Access Compliance Report

Public Rights-of-Way

| Intersection ID: 3595 | Main Street: CLAIBORNE_WOODS_RD | Cross Street: TARPAN_CT | Location: | N |
| ADA ID: 468452C23C58 | Ramp Type: BlendTrans2 | Initial Pass/Fail: Fail | Overall Compliance: No | Severity Score: 1.25 |

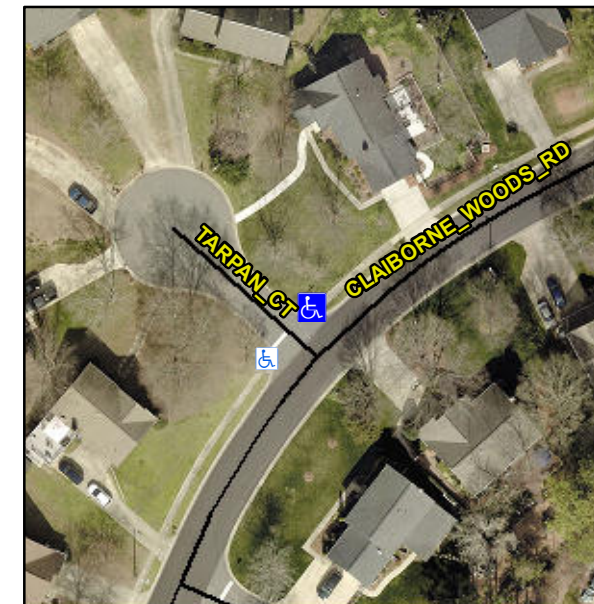
Not Found, R304.5.3

| Compliance | Description | Data | Compliance | Description | Data |
|------------|-----------------------|-------|------------|-----------------------------|------|
| Yes | Ramp Width (in) | 48.0 | No | BlendTrans XSlope (%) | 3.5 |
| | | | No | Curb Slope (%) | 7.8 |

Remove & Replace Curb Ramp With Two New Directional Ramps or Equivalent.
